CITY OF FRANKLIN  
PLAN COMMISSION MEETING\*  
FRANKLIN CITY HALL COUNCIL CHAMBERS  
9229 W. LOOMIS ROAD, FRANKLIN, WISCONSIN  
AGENDA  
THURSDAY, AUGUST 6, 2020, 7:00 P.M.

RE: Site Plan amendment application – 2950 W Statesman Way

Below are comments and recommendations for the Site Plan amendment application submitted on June 16, 2020, to allow for additional parking and a grilling/picnic area in the Statesman Apartments development.

### LANDSCAPE PLAN & SNOW STORAGE

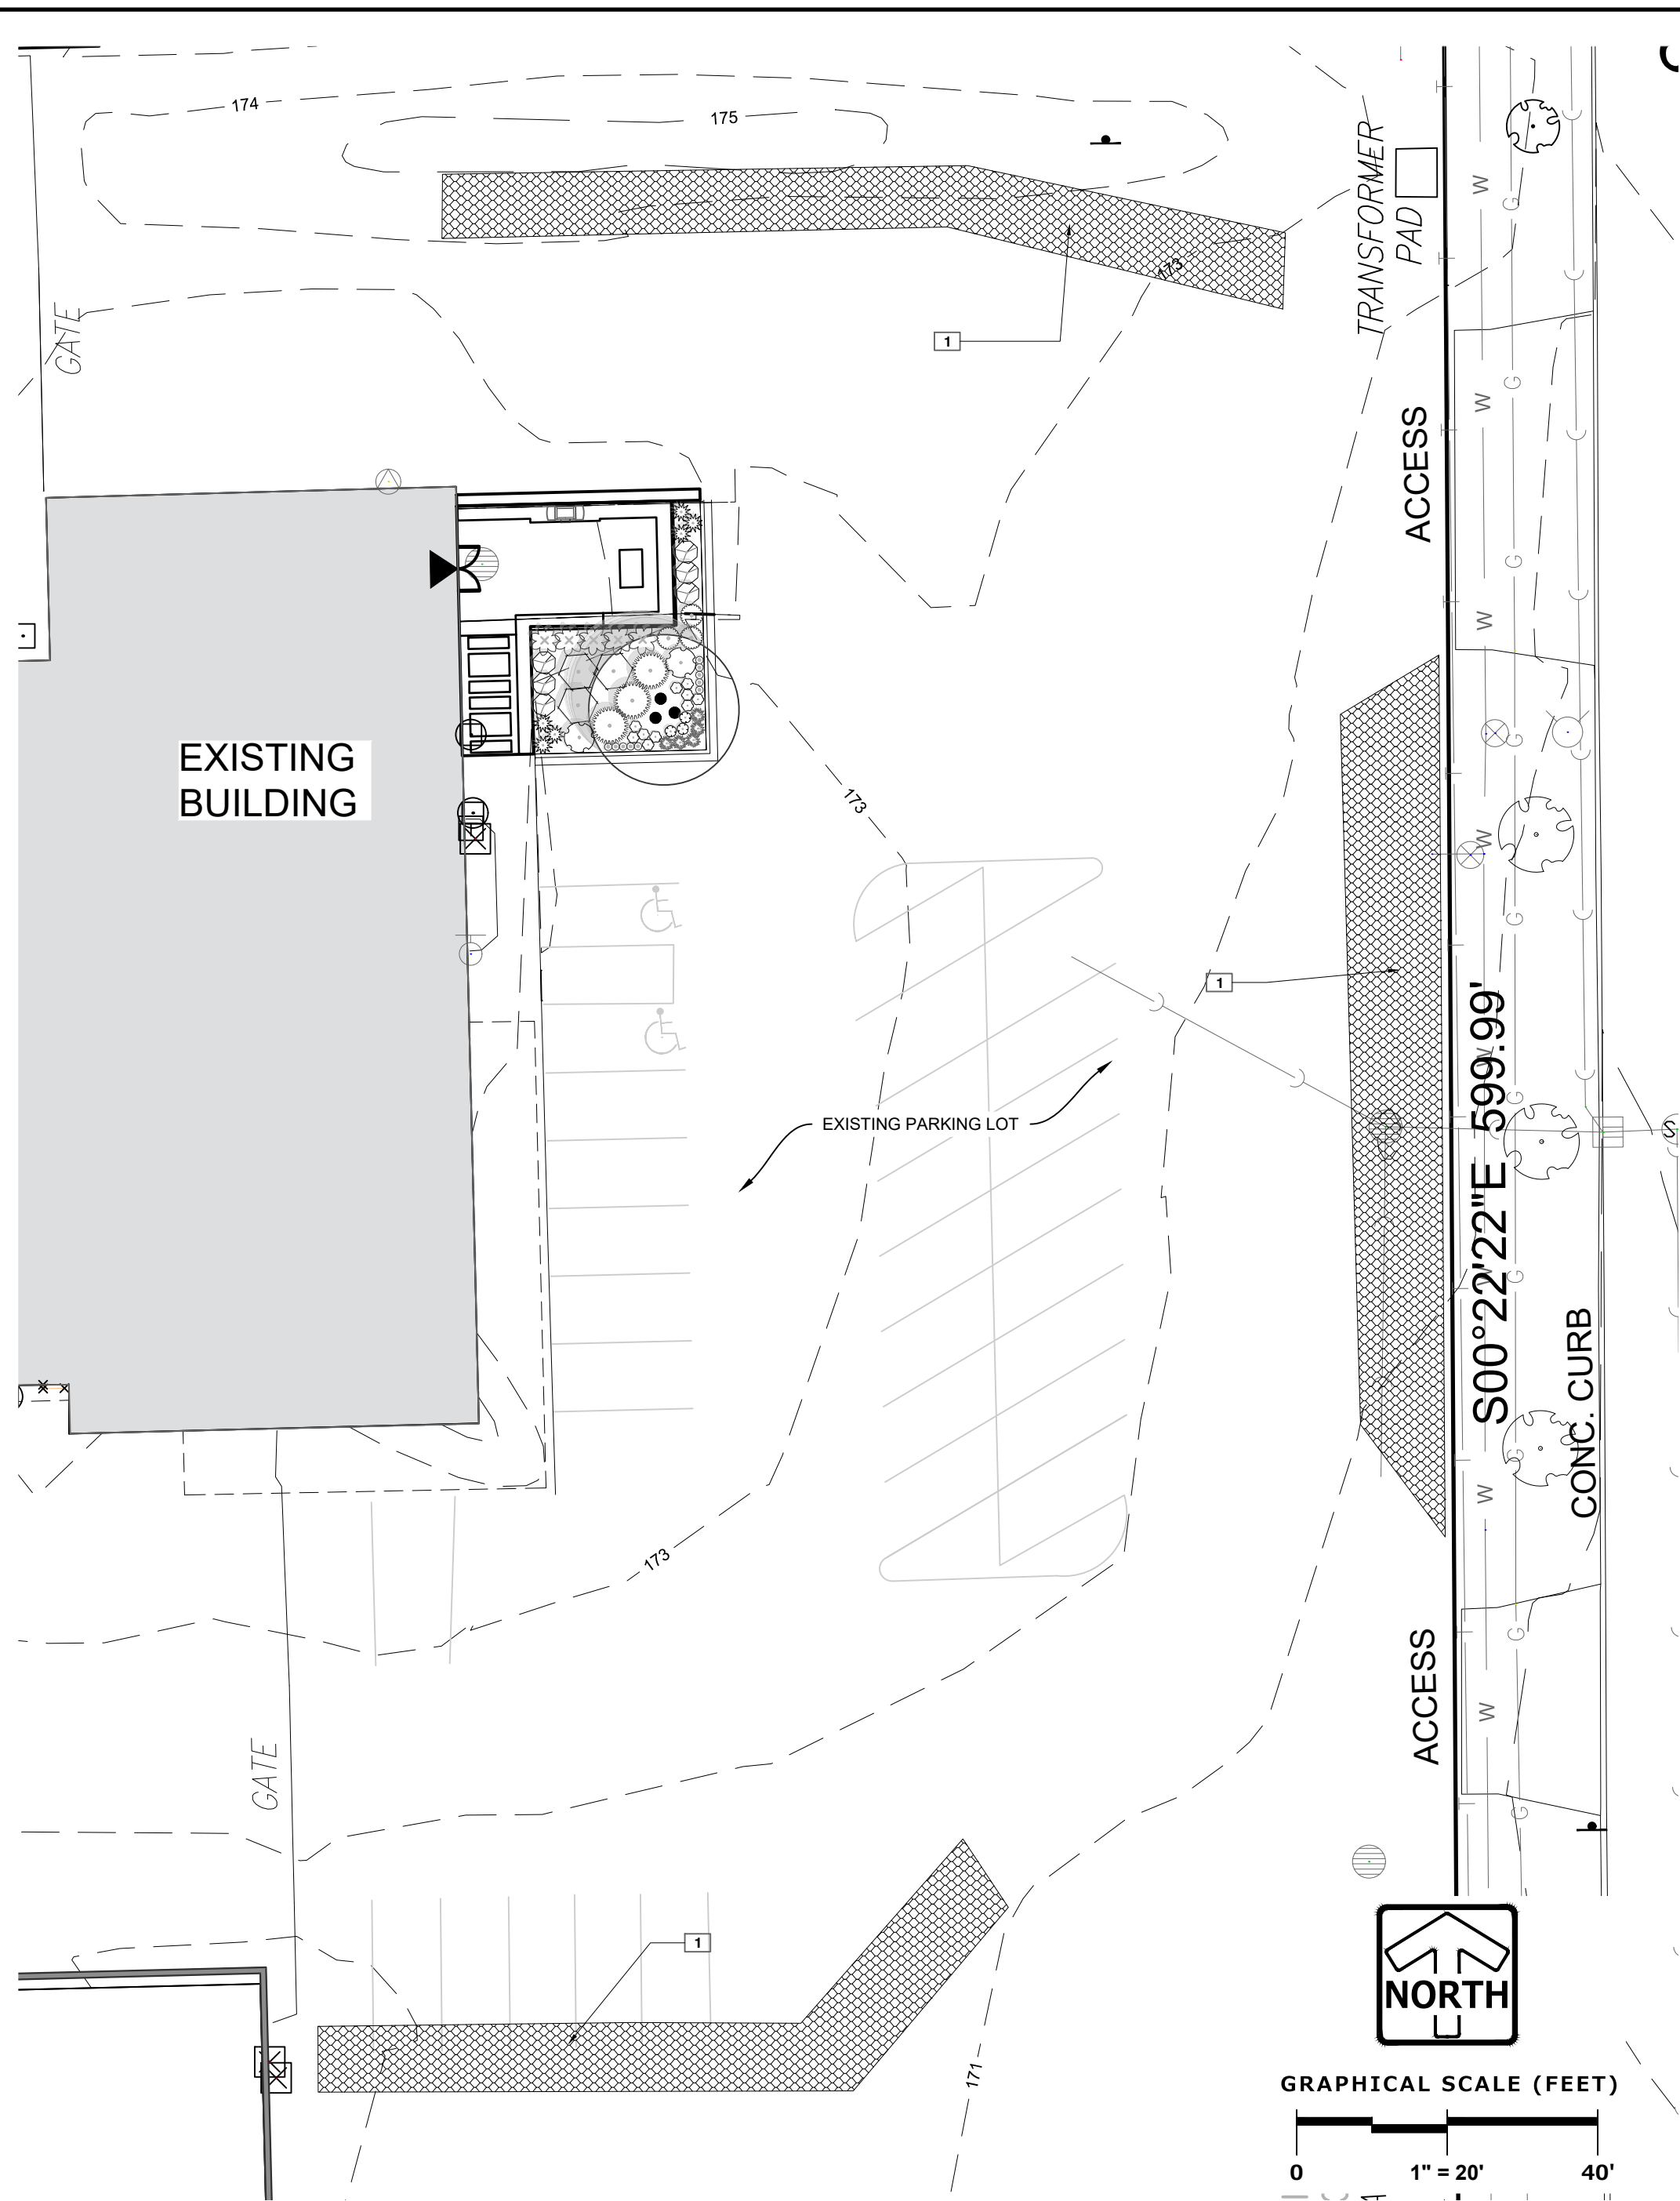
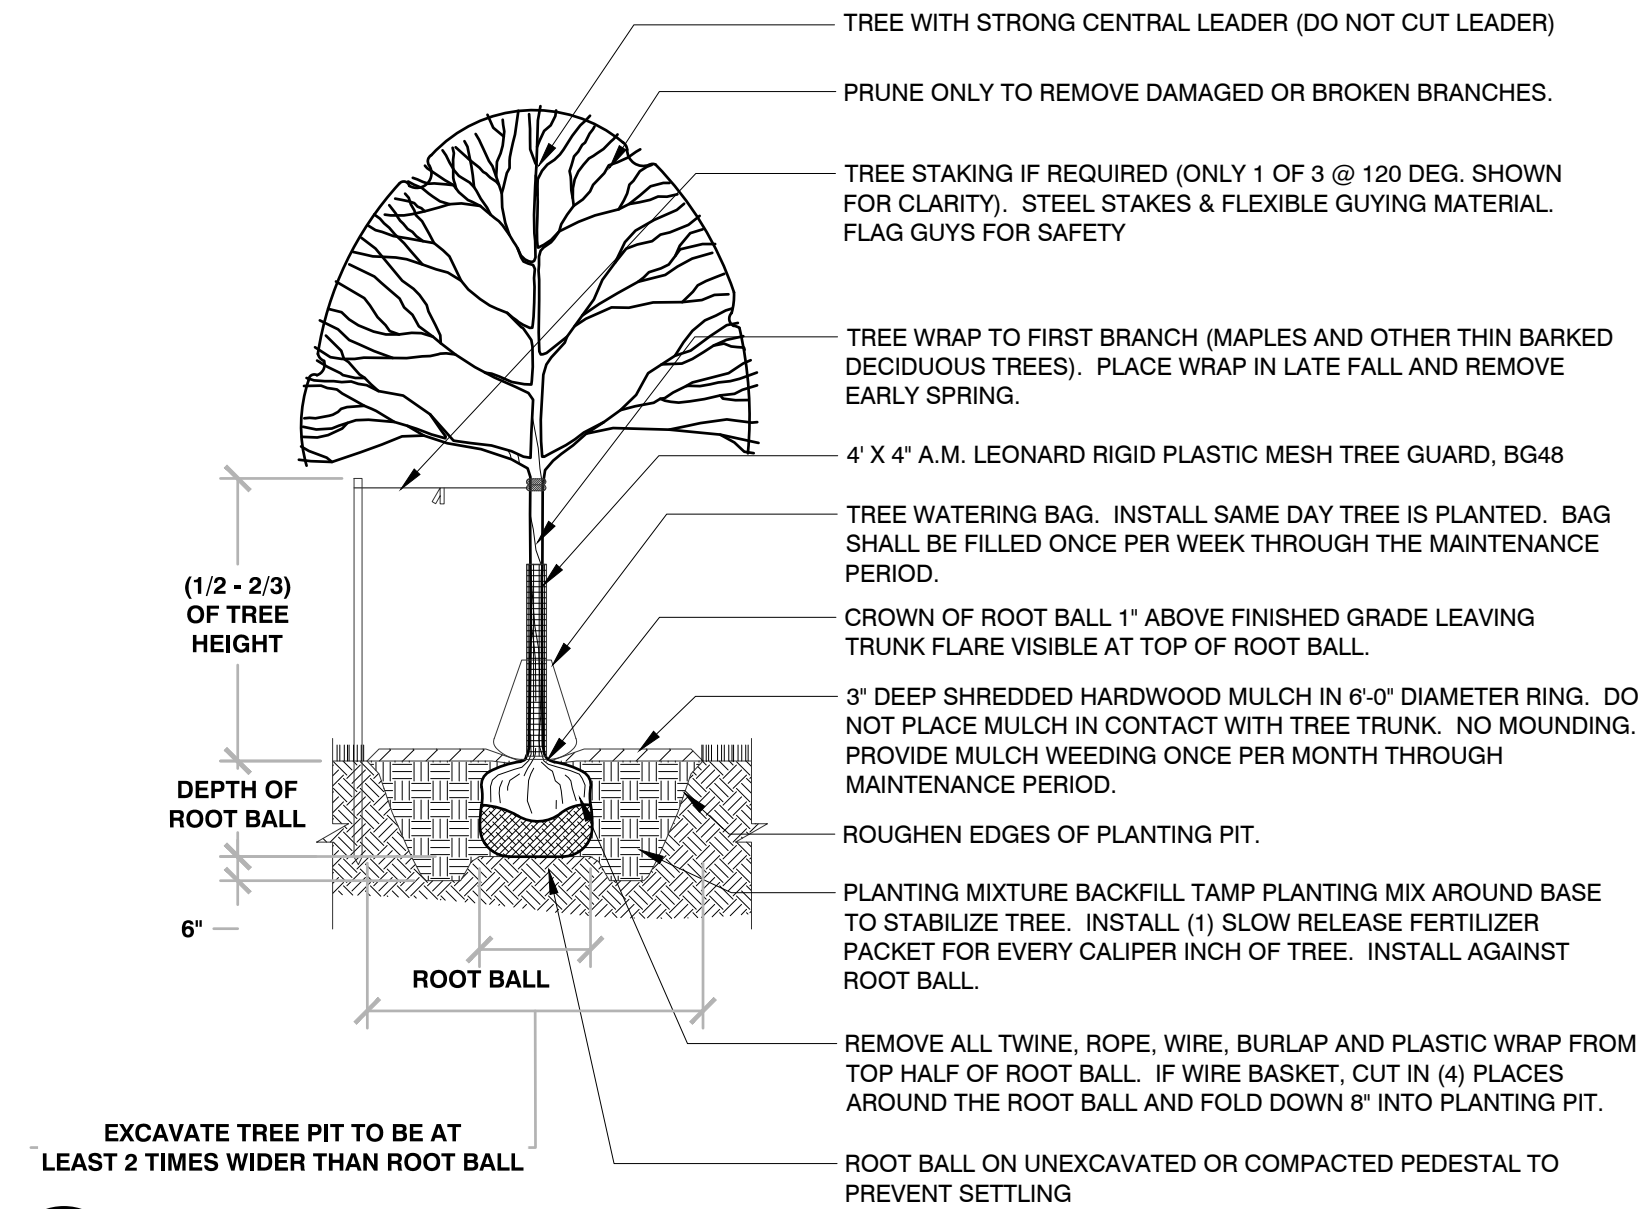
- **RESPONSE: Table 15-3.0309, “Limited Industrial District Development Standards” from the UDO has been added to sheet C-1.**
11. A snow storage plan is required per UDO §15-5.0210(B), refer to this section for snow storage standards.

SYMBOL	DESCRIPTION	QTY	DETAIL
 1	SNOW STORAGE AREAS	3,219 sf
